Item Name: Crosstube Turning Detail

DART AEROSPACE LTD		Work Order:	88977
Description: Crosstube Assembly (206B High Fwd)		Part Number:	D206-667-141
Inspection Dwg: D206-667-141 Rev: C		Page 1 of 2

DRAWING NO. D206-667-141	TITLE CROSSTUBE ASS'Y (206B HIGH FWD)	REV. C	DART AEROSPACE LTD ENGINEERING ORDER		D.E.O. NO. D206-667-141-C-1	SHEET NO. SHEET 1 OF 1	SCALE NTS
DRAWN 97	CHECKED ASS	MFG. APPR. [Signature]	APPROVED [Signature]		DE APPR. [Signature]		
DATE 11.07.15	DATE 11.07.20	DATE 11.07.21	DATE 11/07/21		DATE 11.07.21

REPLACE MAGNOBOND WITH PROSEAL.

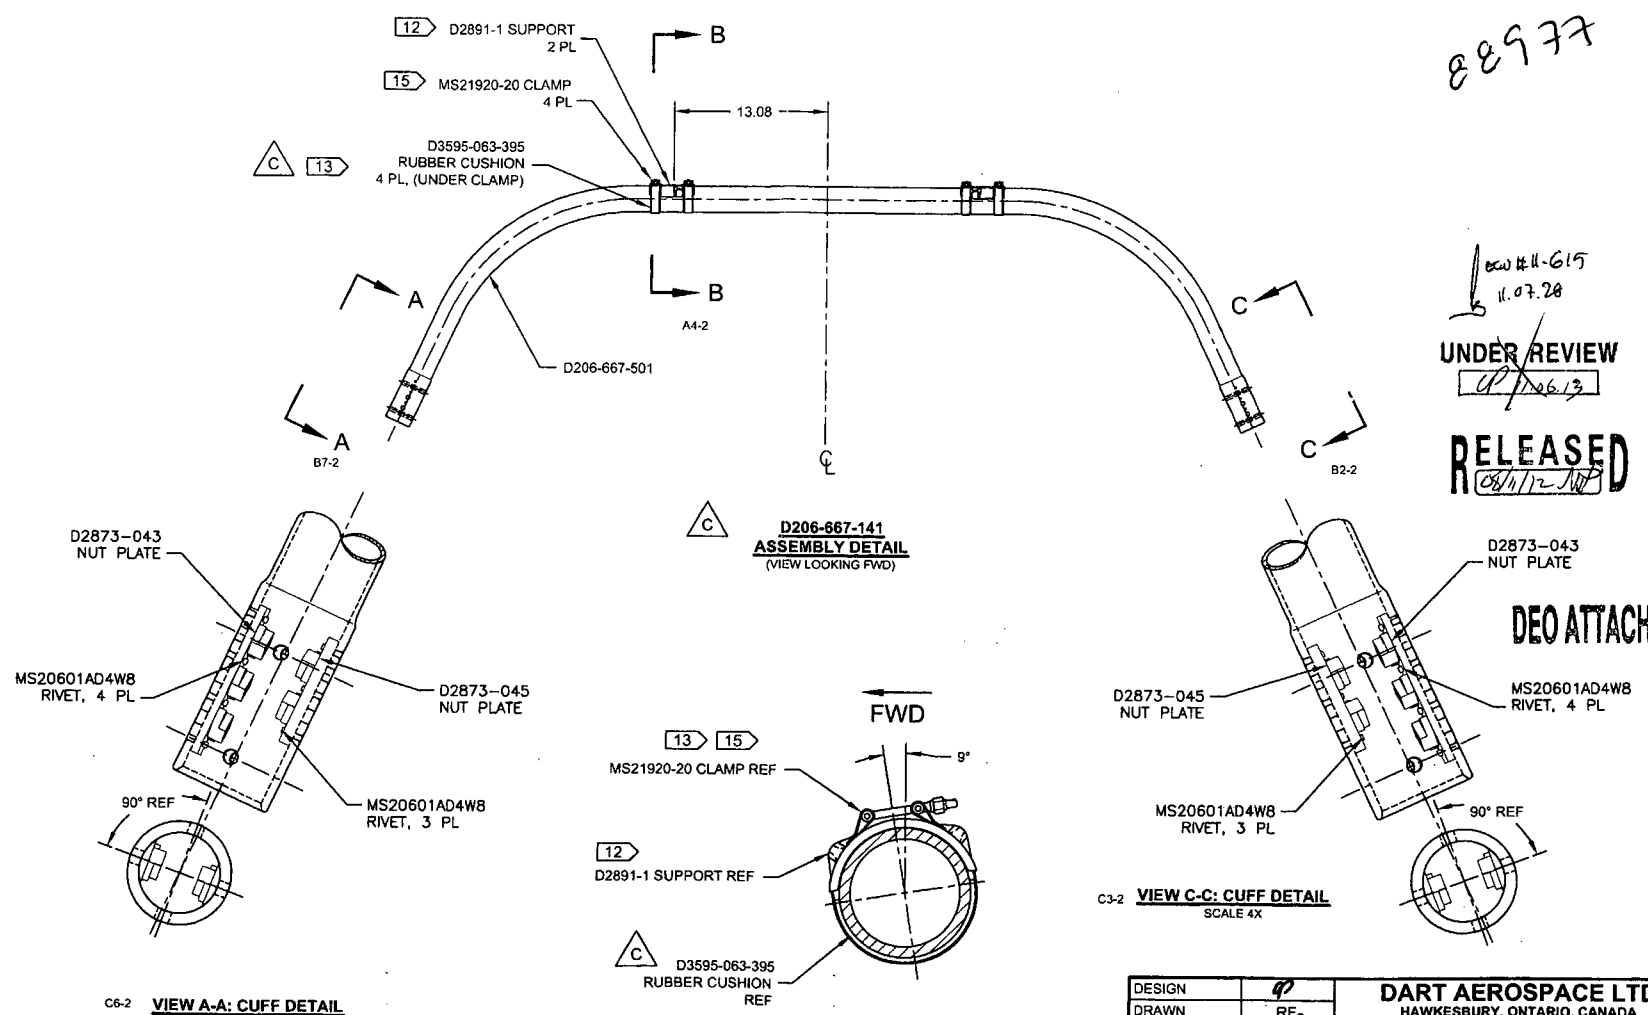
NOTE 12 & 15, SHEET 1 IS AMENDED AS FOLLOWS:

Item	Qty -141	Part Number	Description
9	A/R	PROSEAL 890 B-2	SEALANT, AMS-S-8802 CLASS B-2

- 12) TO INSTALL D2891-1 SUPPORT: ABRASE MATING SURFACE OF SUPPORT AND CROSSTUBE WITH 180-GRIT SANDPAPER AND REMOVE RESIDUE WITH MEK (OR EQUIVALENT). APPLY A 0.04" TO 0.07" THICK LAYER OF PROSEAL 890 CLASS B-2 (OR AMS-S-8802 CLASS B-2) SEALANT TO MATING SURFACE OF SUPPORT.
- 15) TORQUE CLAMPS 80 TO 100 IN-LB. ENSURE AT LEAST 1.5 THREADS SHOWING IN SAFETY AND THAT NUT HAS NOT BOTTOMED-OUT AFTER TORQUING. **PRIOR TO PACKAGING, RE-CHECK TORQUE ON CLAMPS AFTER PROSEAL 890 SEALANT HAS CURED FOR 72 HOURS.**
